ENCODER CABLE

P/N 10850-392

The replacement cable for machines with electronic predetermined stop to length counter system (ESTL)

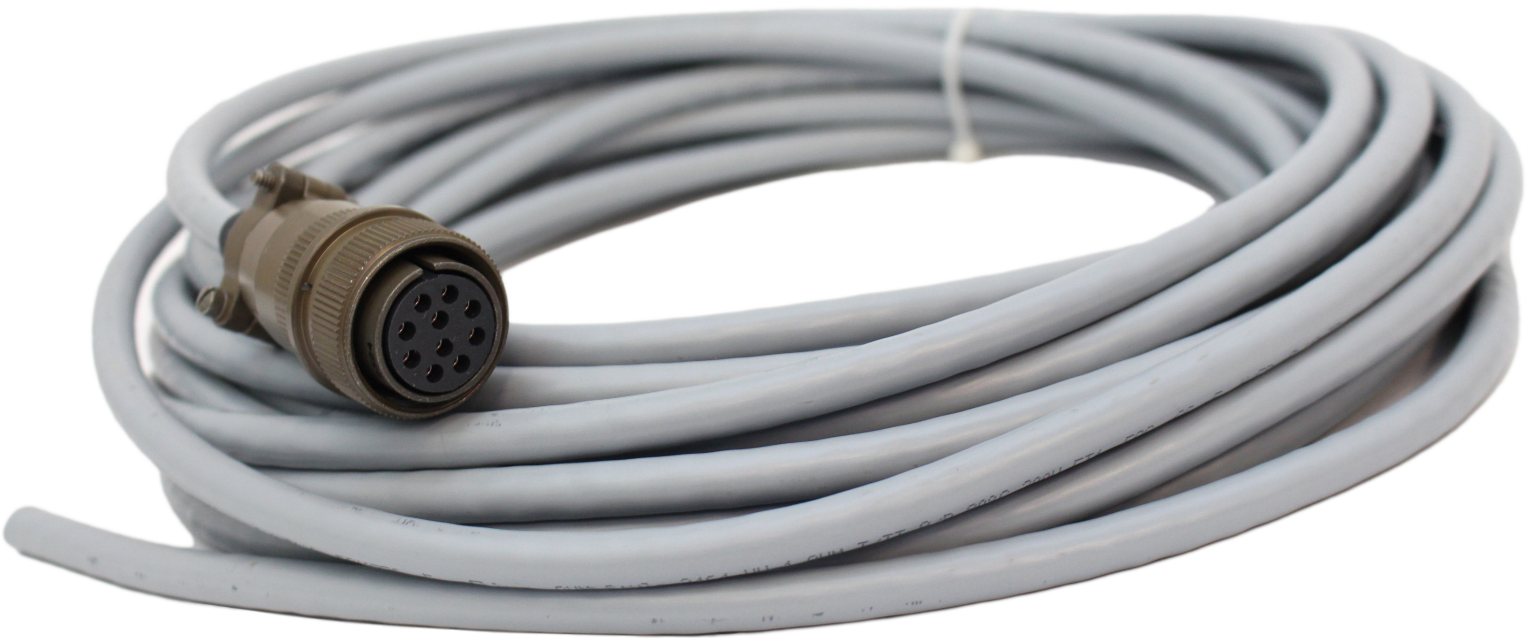
If your new cable is stamped CF211.05.02.02 E310776, the color code has changed

Encoder should be wired as follows:

- Yellow (pin B) to Term 20(+V) (Term 4 Veeder Root)
- Brown (pin A) Term 2 (0V) (Term 3 Veeder Root)
- White (pin D) to Term 10 of Footage Counter or (terminal 18 Veeder Root)
- Green (pin E) to Term 11 of Footage Counter or (terminal 17 Veeder Root)
